Subject: Final Penalty amount for November 8, 2019 Notice of Violation and Compliance Order

Subject: Notice of Violation and Compliance Order

INSPECTION REPORT
CONTRACT WATTS / POLARIS POINT PROJECT
EROSION SEDIMENT CONTROL

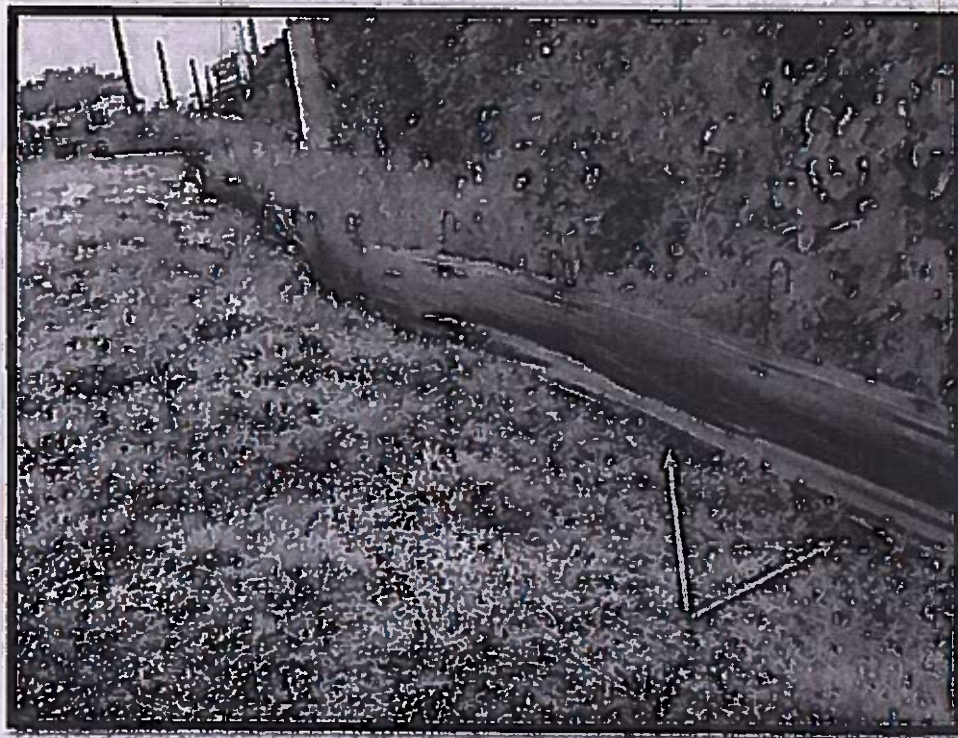
Silt fence along Polaris Point installed improperly. 11/4/2019

WATTS Polaris Point Project Silt fence improperly installed. 11/4/2019

WATTS Polaris Point Project Erosion Sediment Control (BMPs) installed Improperly. 11/4/2019

Erosion Sediment Control (BMPs) with gaps. WATTS Polaris Point Project. 11/4/2019

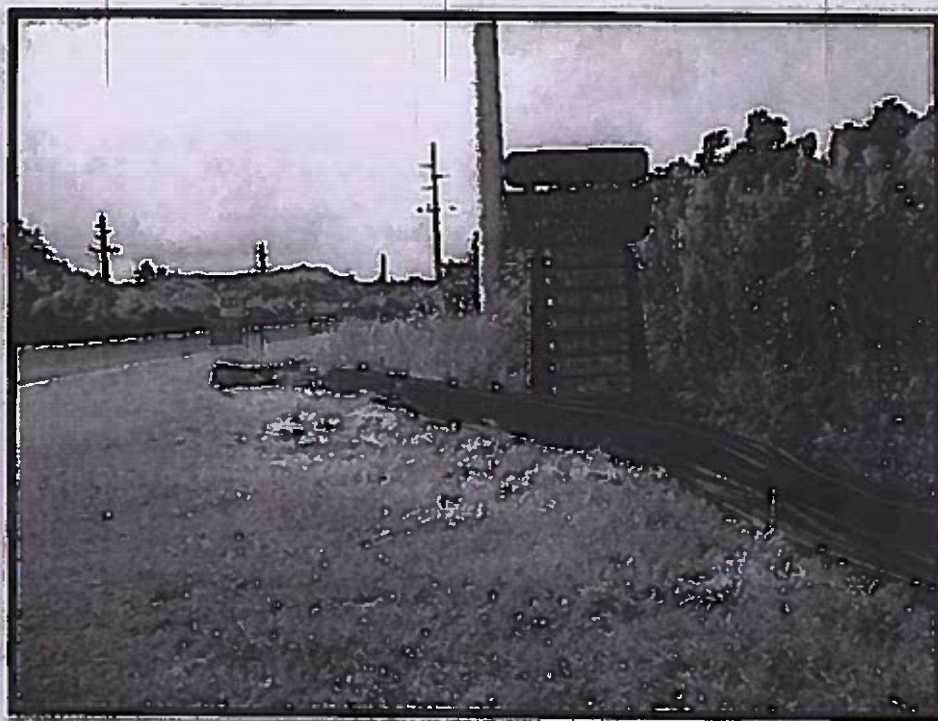
WATTS Polaris Point Project Erosion Sediment Control Barriers installed improperly. 11/4/2019

Gaps can be seen here along this silt fence for the WATTS Polaris Point Project. 11/4/2019

More gaps along this area as well along the Polaris Point Project. 11/4/2019

The whole stretch of WATTS Polaris Point Project their BMPs are improperly installed. 11/4/2019

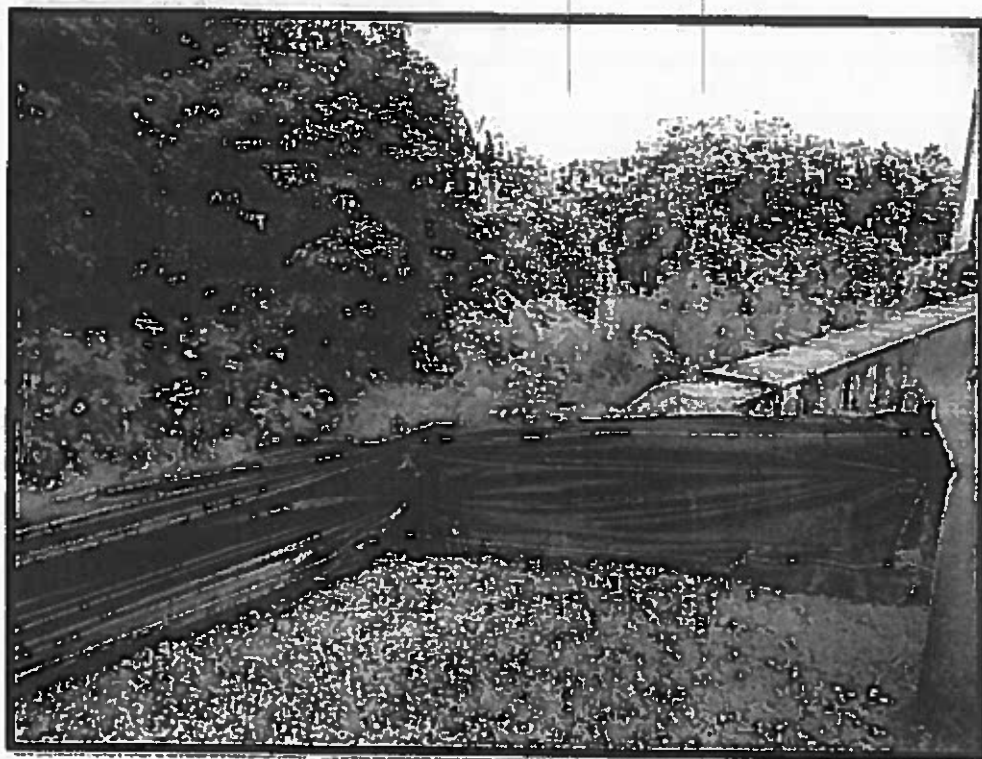
Beginning of the bridge heading towards Naval Sta. where the silt fence breaks. 11/4/2019

The other side of the bridge where the silt fence continues on down towards Naval Sta. 11/4/2019

WATTS Polaris Point Project photo taken 11/4/2019. As of today 11/5/2019 all the dirt seen here has since been put back into the trench that was dug up earlier.
